## Maserati Technical Bulletin

Date: December 20th, 2017  
Bulletin No. MAS001416 - Fuel Delivery Line  
Replacement - U.S.  
Safety Recall Campaign - 363  
Supersedes: N/A  
Section: Compliance

**Model: Quattroporte (M156) and Ghibli (M157)**

**Subject: Vehicle Safety Recall Campaign 363 – Fuel Delivery Line Replacement**

Fig.1

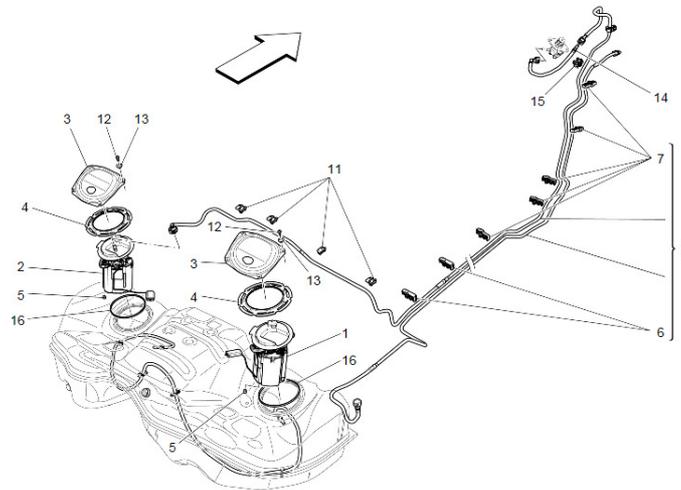
Maserati S.p.A. and MNA have determined that the above described vehicles were manufactured with fuel lines (Num. 9 in Fig.1) that may weep or leak fuel as a result of an assembly process used by a supplier during fuel line production. Potential fuel leaks may occur at any location along the fuel line due to the introduction of foreign particles between the metal fuel line and plastic fuel line during the connection process (due to the supplier's insufficient cleaning process of the fuel line), causing scratches on the plastic fuel line portion. A weeping or leaking fuel line, over time, and in the worst case scenario, can lead to a fire in the engine compartment or underneath the vehicle.

The original 1 piece fuel delivery line will now be replaced by the above kits which contain 3 lines. The engine connection line (1), the body line (2), and the fuel tank connection line (3).
